City of Mississauga

City Department and Agency Comments

Property Address: 2892 Tradewind Drive

File:A144.21

Appendix 1 – Transportation and Works Comments

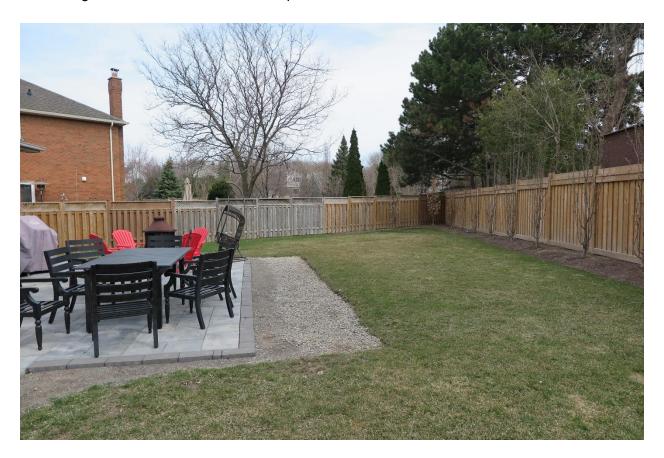
We note that we have no objections to the requested setback to the U3 Zone (utility) and also no drainage related concerns with the request.
